PRE-PRODUCTION PCBA INSPECTION

Date: 26-10-2020
Revision: 1.0
Author: Tony Little
Product: Electric Skateboard
Company: Globe Brand

4.2 OLED PROTECTION

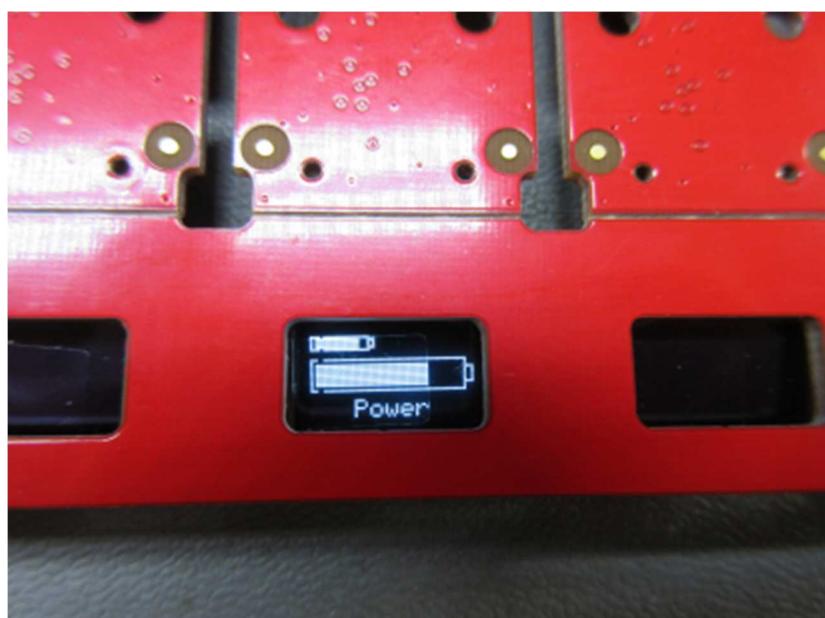
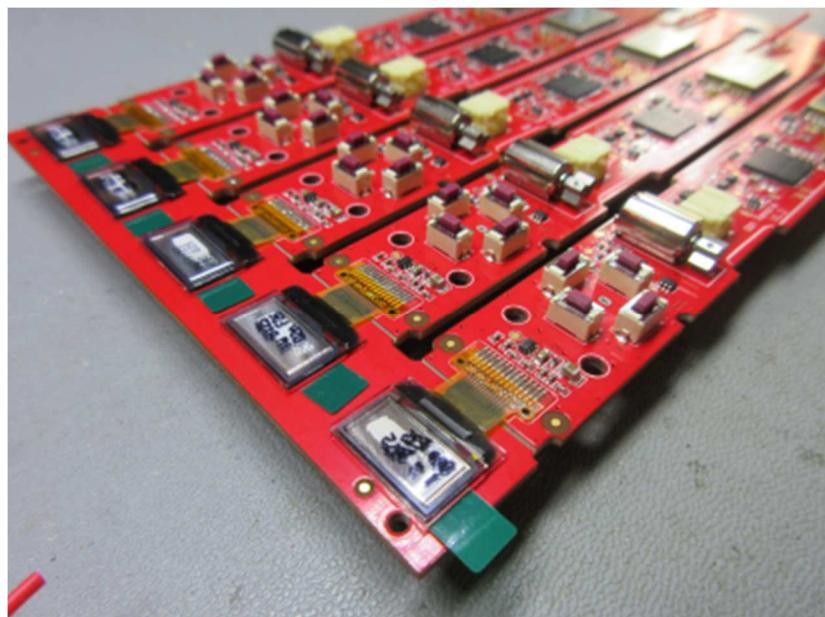
OLEDs have the desired additional support for handling and shipment.

4.3 OLED ALIGNMENT HOLES

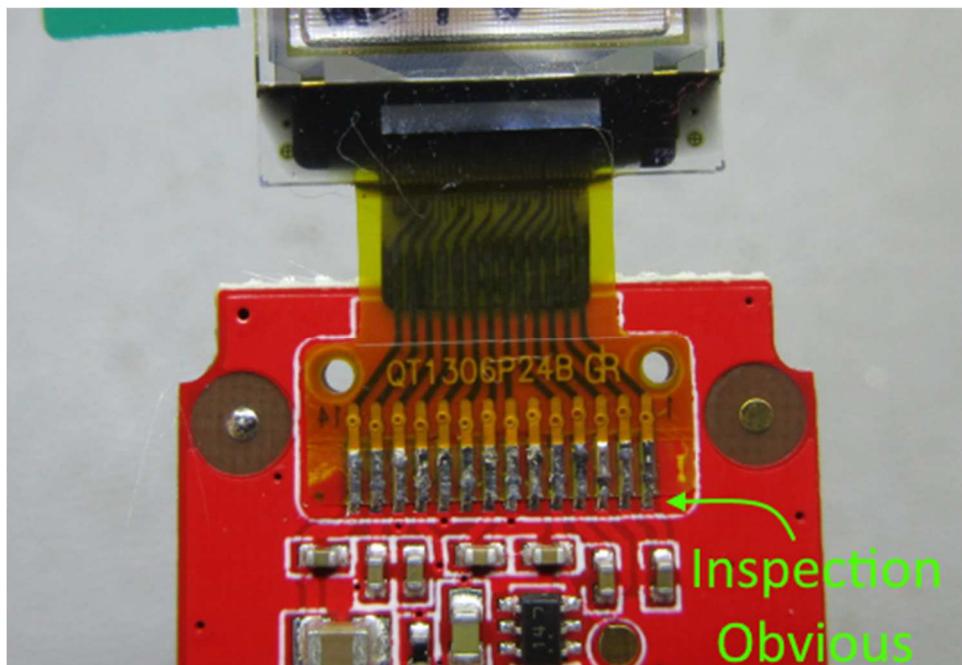
OLED alignment holes moved 0.25mm and increased to 1.1mm diameter. This is to improve tab soldering inspection and jig alignment fitment.

Samples would have been prepared without a jig for alignment, which is noticeable. Given due consideration, change gives the desired obvious soldering edge inspection.

4.4 ANTENNA PROTECTION

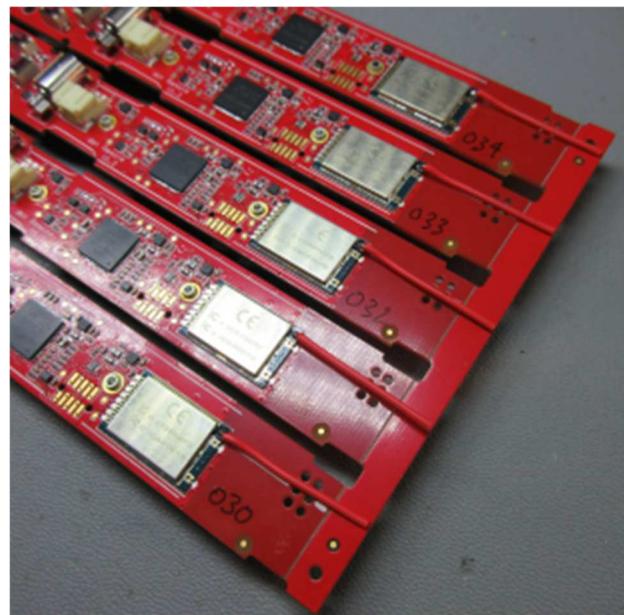
The extended panel breakoff is just enough to avoid a lot of antenna displacement while handling and being packaged.

4.5 DE-PANELED

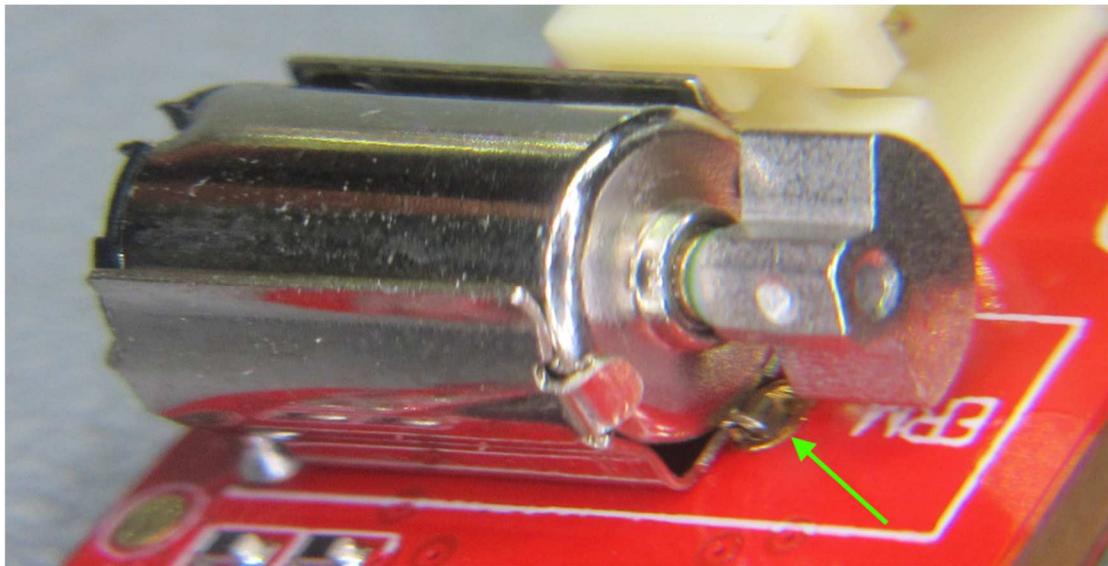
De-paneling easy. The OLED end should be broken off without touching the OLED.

4.6.2 WIRELESS MODULE ALIGNMENT

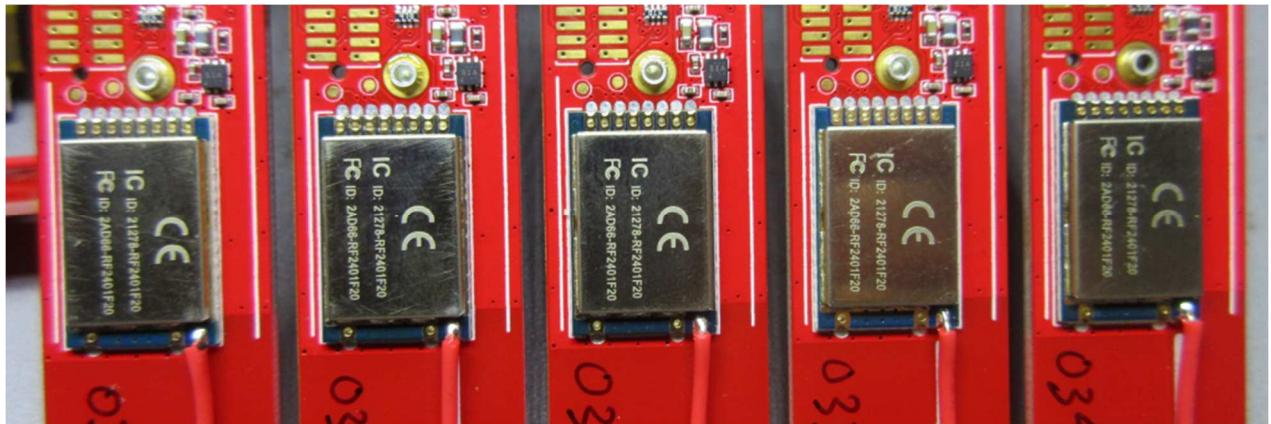
Reflowed alignment is good.

4.6.3 USB CONNECTOR ALIGNMENT

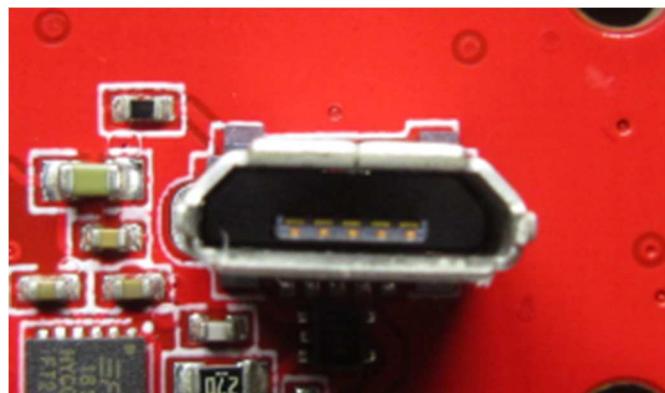
7 units had very good USB connector. The 3 below were not ideal.

Units FFFFF030, FFFFF02C (worst example), FFFFF02D.

4.7.1 FFFFF02B

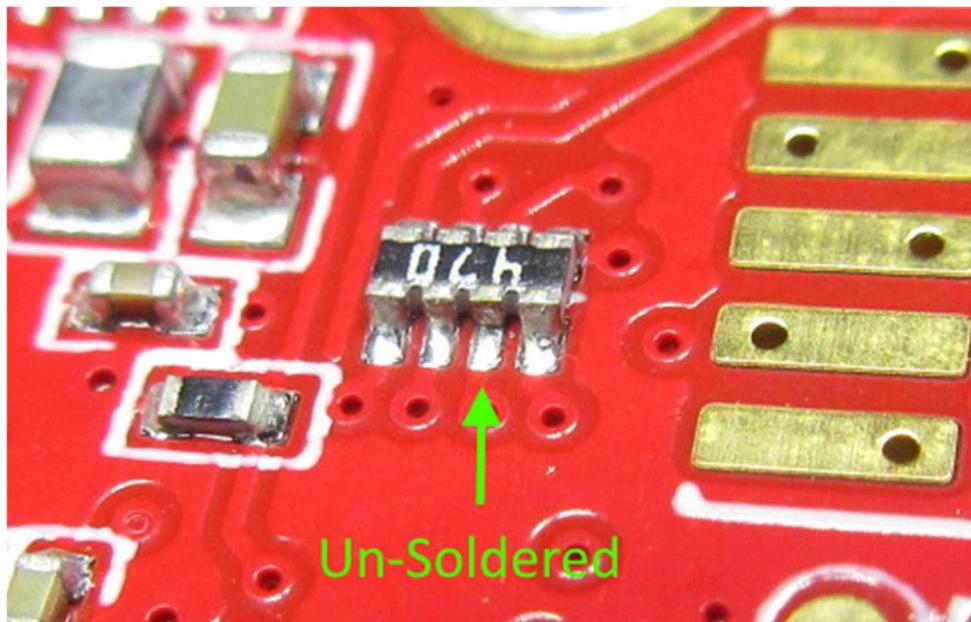
Wireless not functioning.

Found R25 with un-soldered contact.
